## PRODUCT INFORMATION – INF074-02

### MODIFICATION TO KESTREL TERMINAL FOR 12V READER

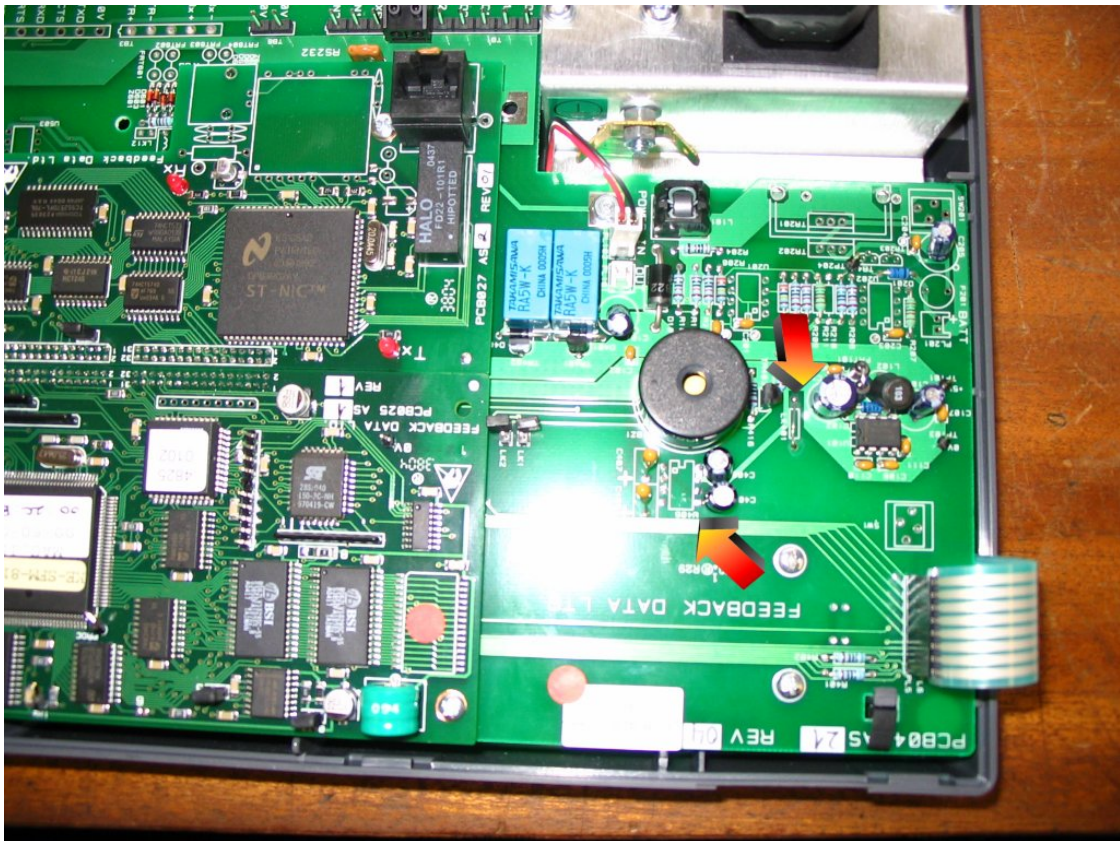
To connect the new 12V Paxton magstripe reader to a Kestrel, the following modification has to be applied to the main pcb.

Add wire link as indicated (LK401)

Remove chip as indicated (U406)
